July 7, 2020

**To:** Planning Commission

**RE:** Application No. V-1437 by LWO Properties LLC, holder of a purchase agreement with the City of Owatonna, a request for a variance to allow a 12' rear setback where a 20' rear setback is required. Also a variance to allow a driveway slope of 7% where a maximum of a 5% slope is permitted for a parking lot or driveway.

**LWO DEVELOPMENT, LLC**  
**EASTGATE APARTMENTS**  
 OWATONNA, MN

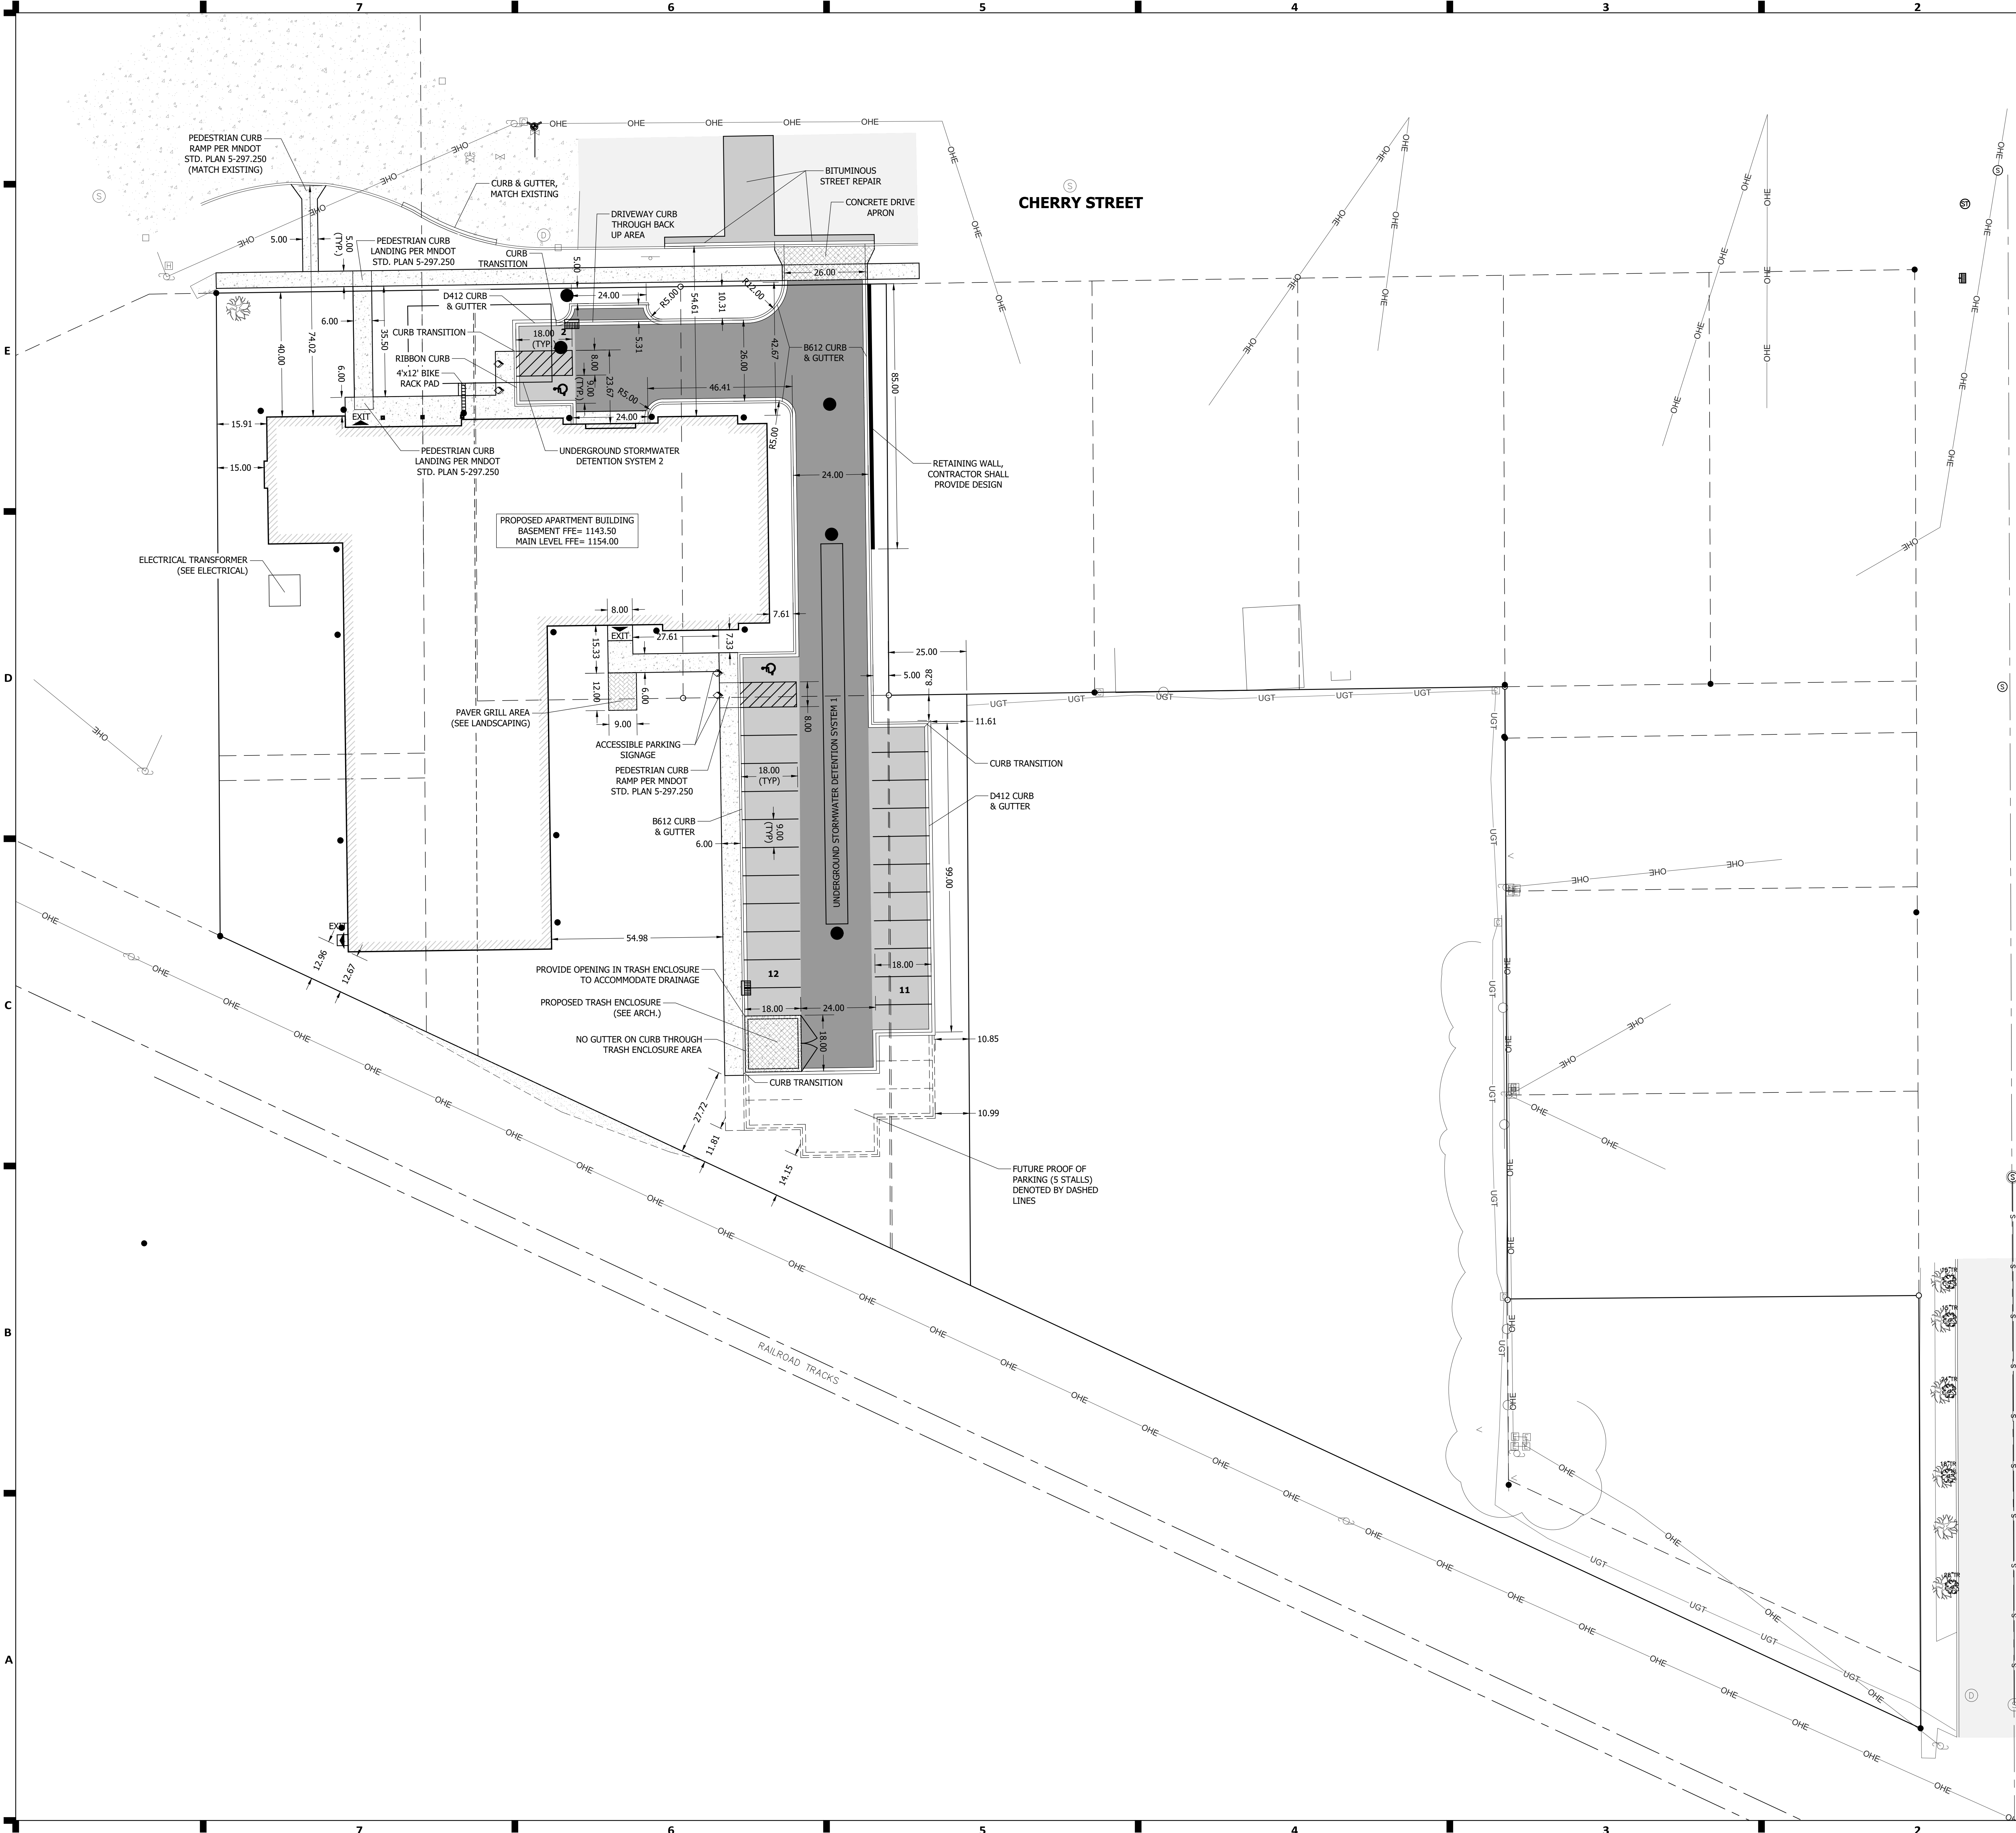
- ◆ The applicant is requesting a variance to allow a 12' rear setback in the southwest corner of the building where a 20' rear setback is required. The majority of the rear wall of the building meets the setback requirement.

Staff is recommending approval a variance to allow a 12' rear setback where a 20' rear setback is required and a variance to allow a driveway slope of 7% where a maximum of a 5% slope is permitted for a parking lot or driveway. with the following condition.

- 1) The variances shall be contingent on the approval of the conditional use permit.

DATE: 06/19/2020  
 PHASE: CONSTRUCTION DOCUMENTS  
 PROJECT: 02220002  
 SHEET: C301  
 GRADING PLAN

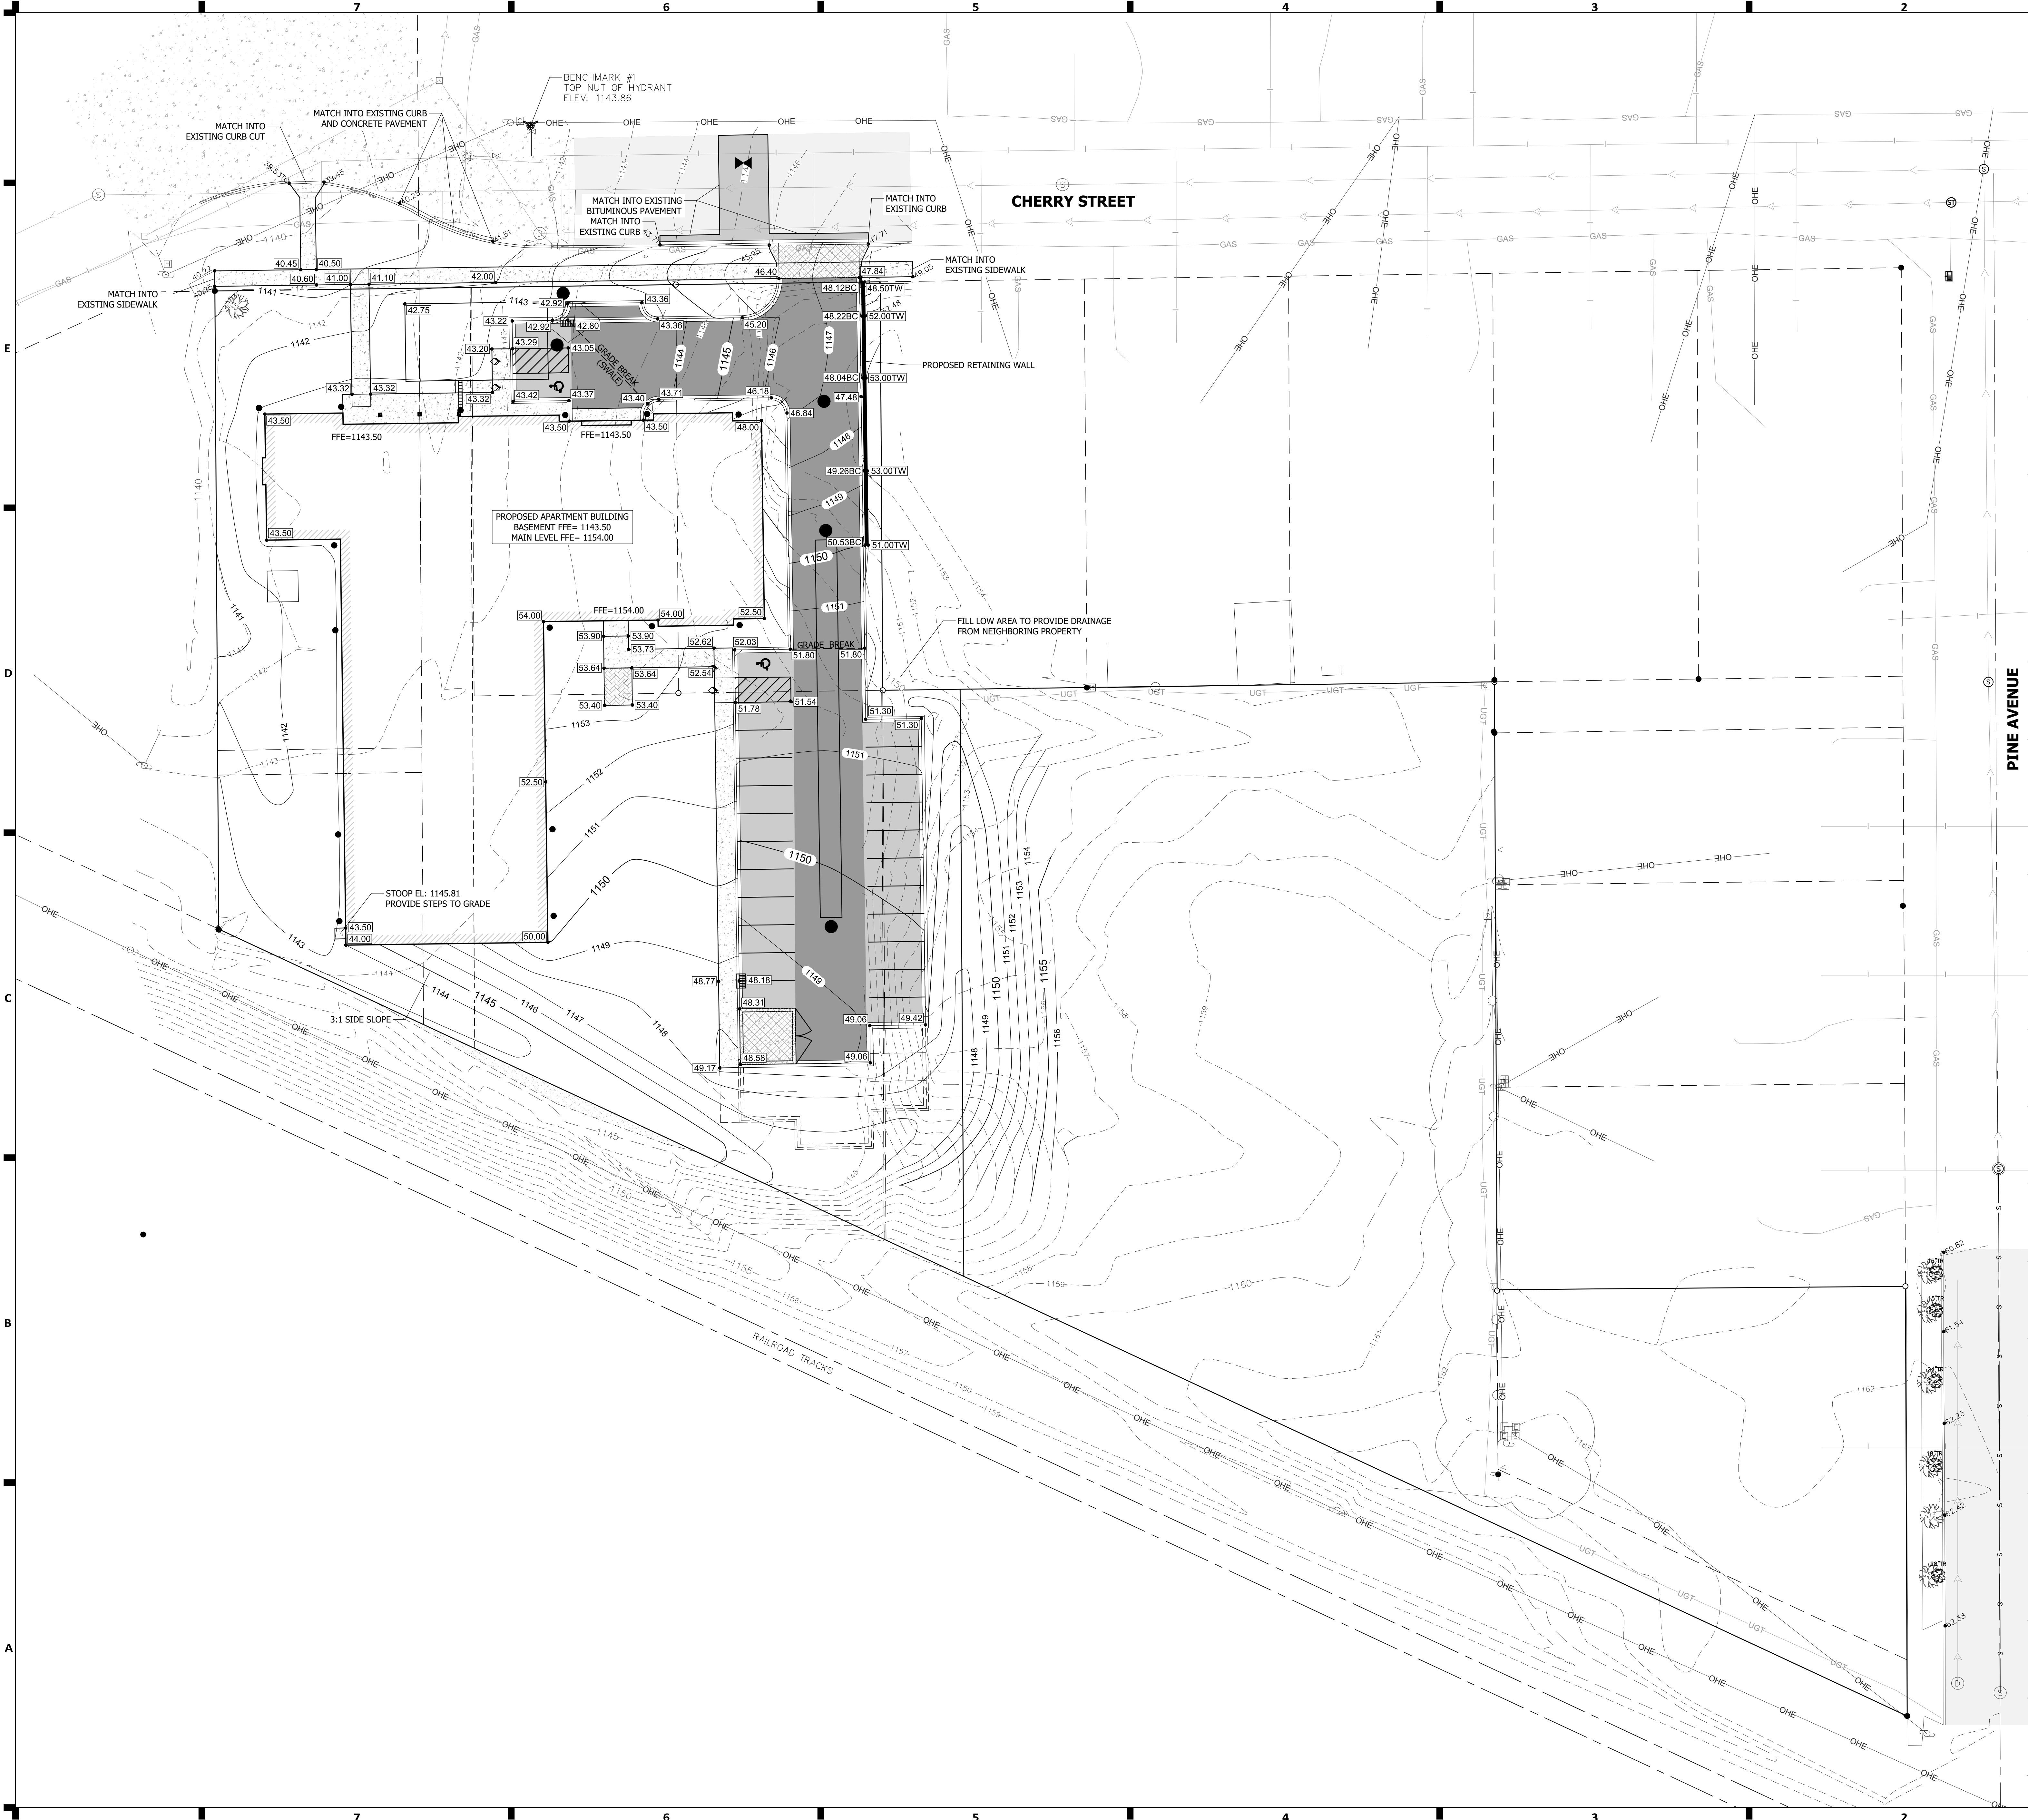
- ◆ The rear of the property is bordered by the railroad tracks. No neighbors will be impacted by this closer setback.
- ◆ The applicant is also requesting a variance to allow up to a 7% slope where only a 5% slope is required. The large slope areas are around the northeast corner of the building.

- ◆ This is caused by trying to get access to the underground parking as well as getting to the rear parking area from one driveway.
- ◆ The applicant will also be constructing a retaining wall in the NE corner of the lot in order to lower the driveway as much as possible to keep the grades at under 7%.

- ◆ The City Engineer supports this request and feels that it is a better option than the two driveways.
- ◆ Due to some of the funding on the project the applicant is not permitted to exceed 7% grades on any of the drive areas. Although they are close they are not planned to exceed 7%.
